Application	G	eneral Data
Public hearing and consideration of a	Planning Commission	April 8, 2021
request for a Special Use Permit, to	Hearing:	
construct a single-family dwelling on	City Council	April 17, 2021
developed, substandard lot.	Hearing:	
Address:	Zone:	R-5/Residential Single Family
7 West Walnut Street		
Applicant: Edgardo Maravi	Small Area Plan:	Potomac West

Staff Recommendation: APPROVAL subject to compliance with all applicable codes, ordinances and the recommended permit conditions found in Section III of this report.

<u>PLANNING COMMISSION ACTION, MARCH 2, 2021:</u> On a motion by Commissioner Lyle, seconded by Vice Chair McMahon, the Planning Commission voted to defer Special Use Permit #2020-00108. The motion carried on a vote of 7-0.

Figure C: Front Elevation Does Not Indicate Porch Railings as Part of the Design

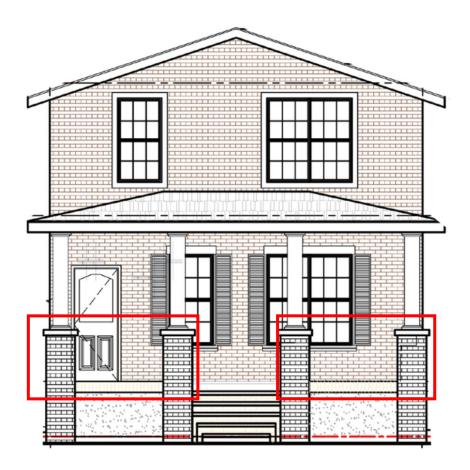
There are a number of comments about the porch treatment. The existing bungalow porch details and columns are quite charming. The porch as illustrated in the report lacks clarity and details in a number of areas. There are no railings shown on the front elevation but railings are shown on the side elevations and alluded to on the plan. (See Figures C&D). There should be wood railings and wood stair railings at the steps. The porch facia below the end of the roof should have a facia board, typically slightly recessed, and the end of the front gable should have a significant facia board trim piece where the roof meets the vertical facia (*See Figures K, L, M & N*). The architectural details noted above for the brick windows, brick pattern, end gable and porch area would be applicable to any proposed new infill brick house on this site independent of its form.

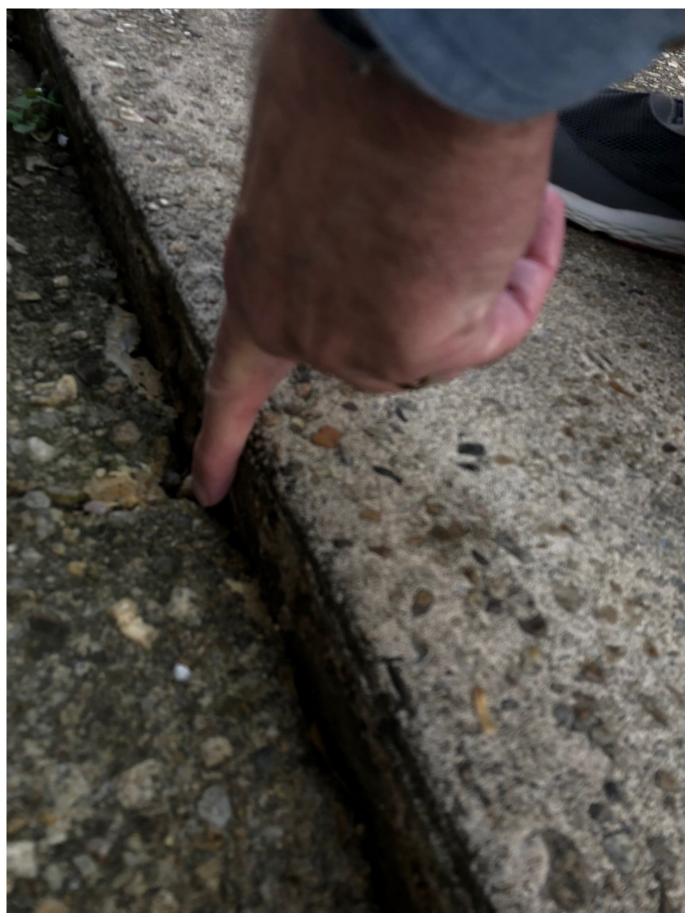
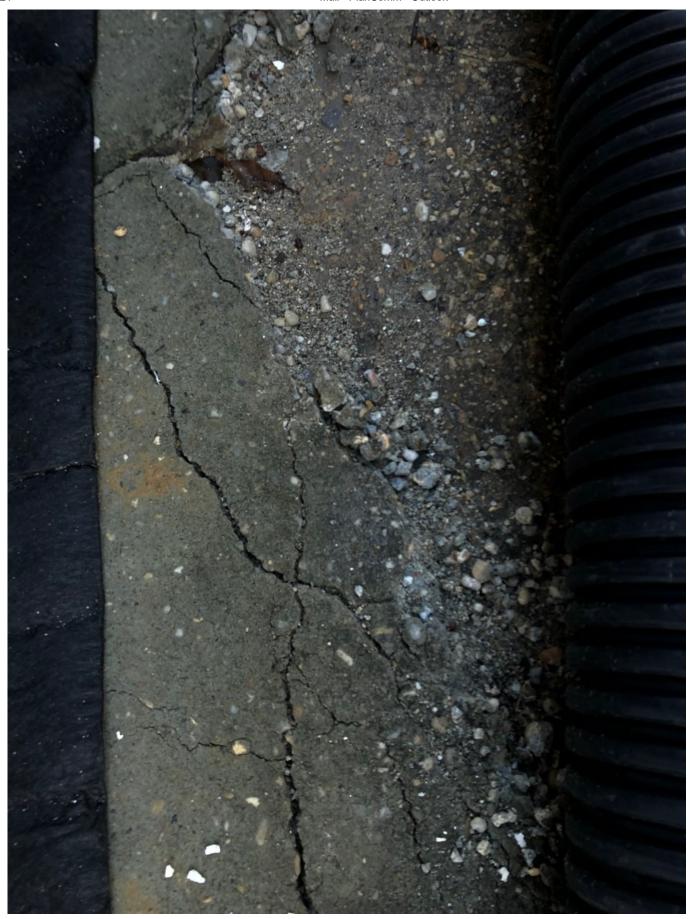
There were some original cracks on the driveway itself as Edgar has provided. The attached photos show the cracks that have happened recently on the cement apron against our house, which are recent.
